Groundwater Transfer Review Summary Form

Transfer/PA # T- 13728

Ground Water Review Form:

Application: T-13728

Theis Distance Drawdown Modeling

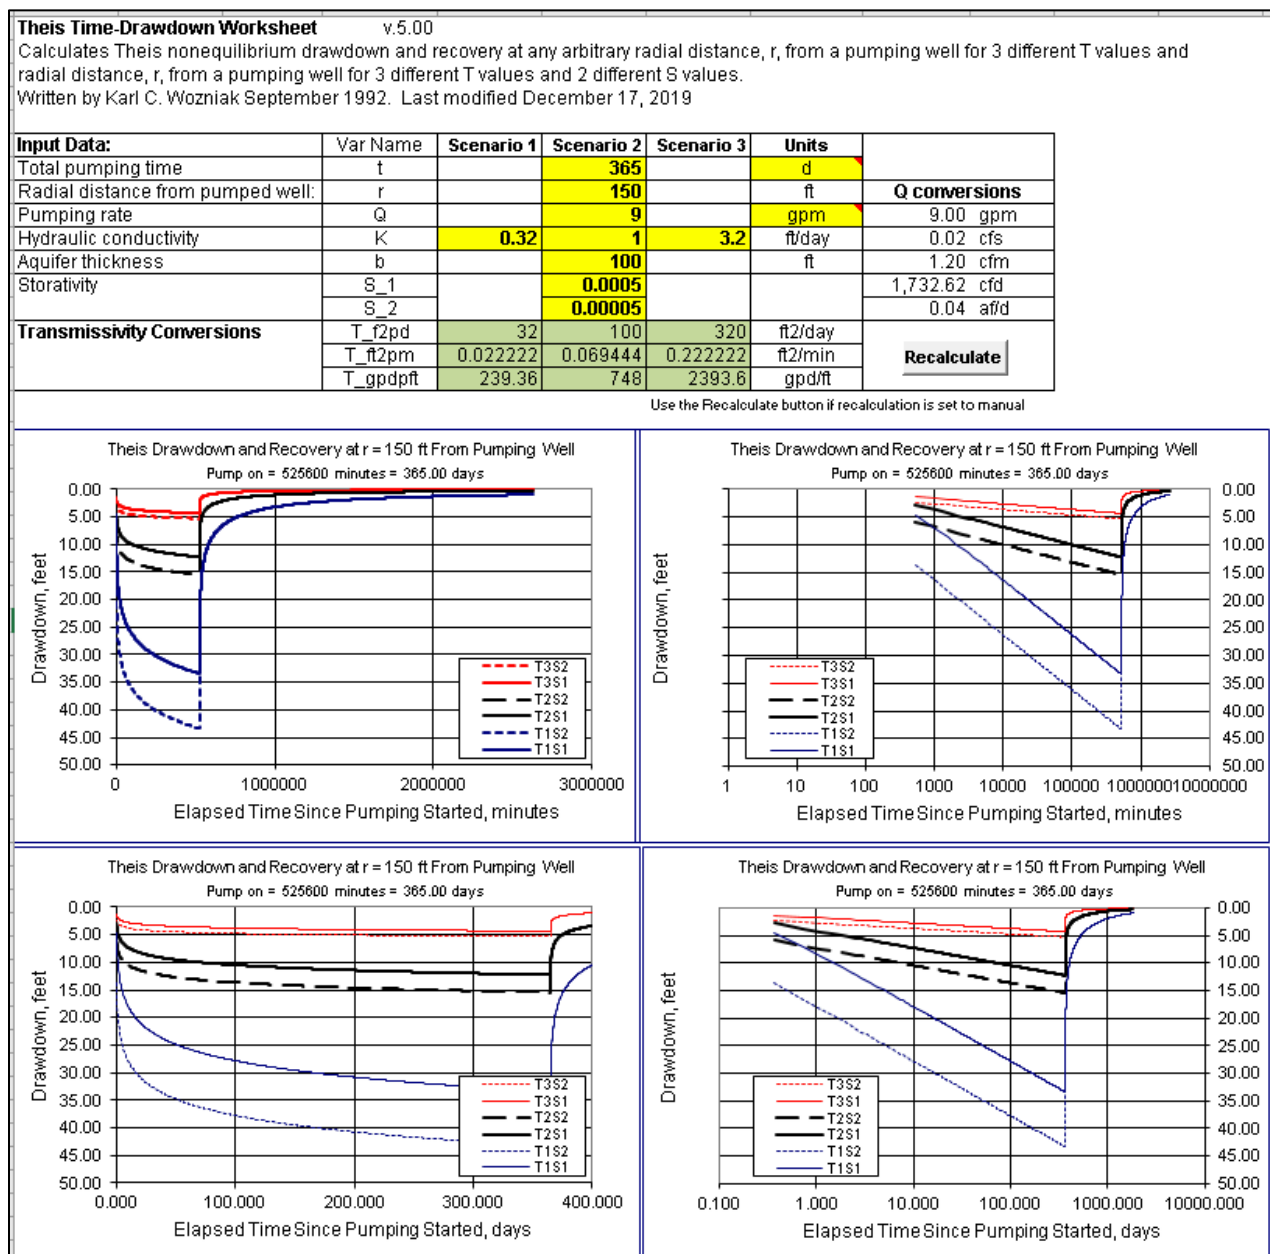
The scenario below simulates the effects of Well 1 pumping at its maximum rate. Model parameters approximate bulk aquifer properties. This model represents the maximum well-to-well interference, and actual drawdowns are likely to be less.
